## Product Change Notice (PCN)

**PCN Number:** PCN-0460571R-01

**Product(s) Affected:** PJ-008A, PJ-008B

Current version	New version
Outlook

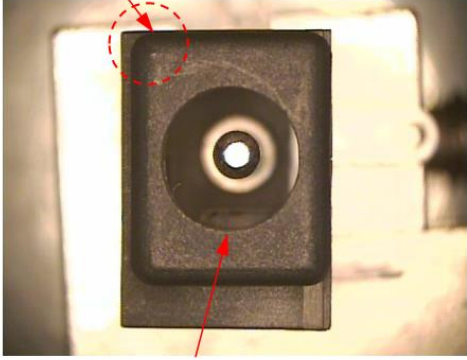
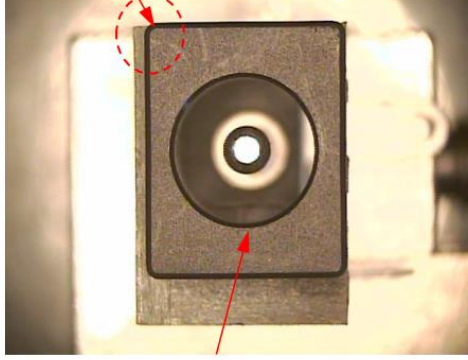
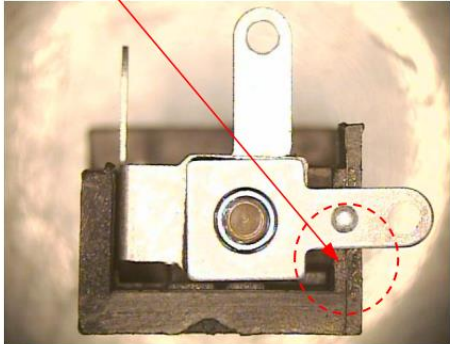
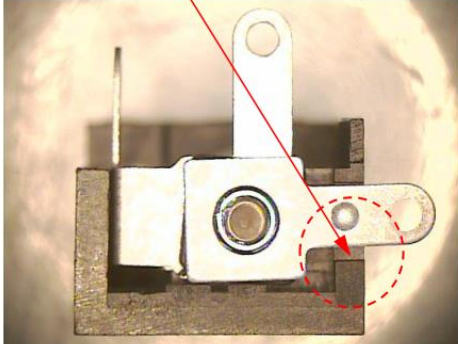
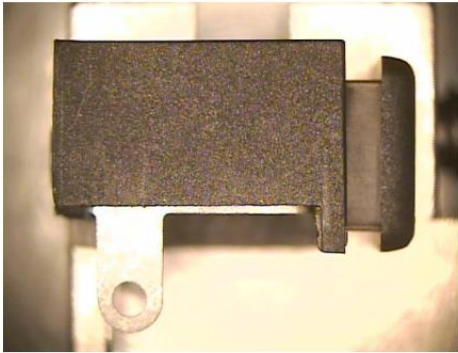
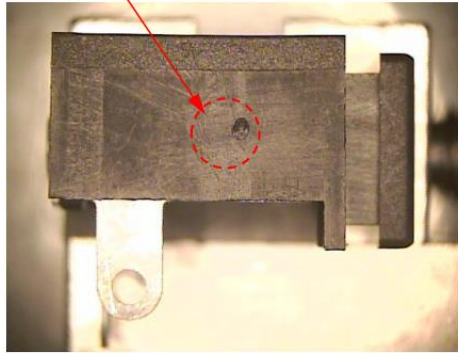
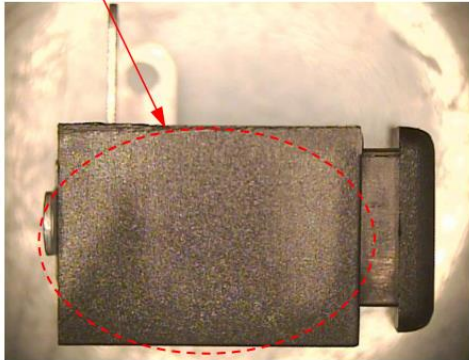
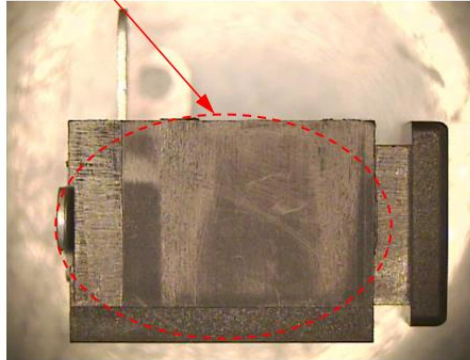
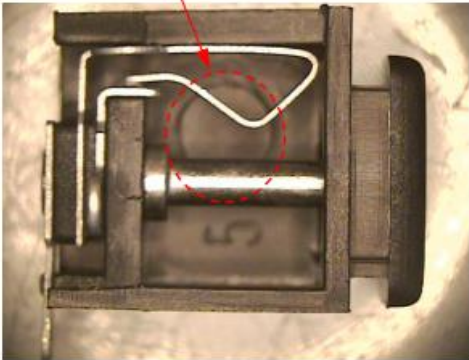
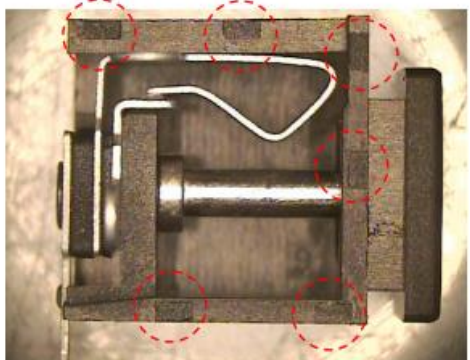
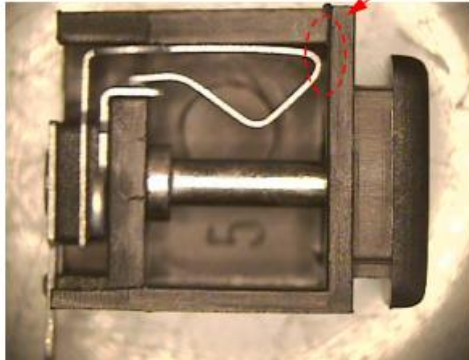
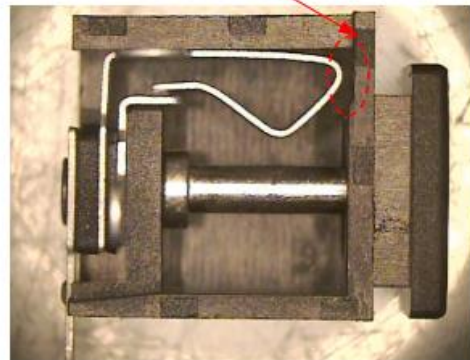
**Reason(s) for Change:** The existing mold of PJ-008 items have been used for a long time, and unable to maintain efficient production. To ensure the quality and lead time of production, a redevelopment of the mold is in progress. We have taken this opportunity to also optimize the product design to enhance quality.

**Description of Change:** New mold will optimize the design and enhance the appearance. The electrical structure and function will remain the same. Comparison photos are below:

Front	<p>Looks more round on the corner</p>  <p>Jack hole with chamfer</p>	<p>Looks less round on the corner</p>  <p>Jack hole without chamfer</p>
Back	<p>Plastic wall contact with pin 1</p>  <p>Plastic wall contact with pin 1</p>	<p>Plastic wall is dented and keep away from pin 1</p>  <p>Plastic wall is dented and keep away from pin 1</p>
Left	<p>Without injection mark</p>  <p>Without injection mark</p>	<p>With injection mark</p>  <p>With injection mark</p>

Right	<p>Matte on surface</p> 	<p>Smooth on surface</p> 
Bottom	<p>Holding pin is located inside of the part</p> 	<p>Pin is held by plastic wall</p> 
Bottom	<p>Plastic wall is flat</p> 	<p>Plastic wall is dented</p>
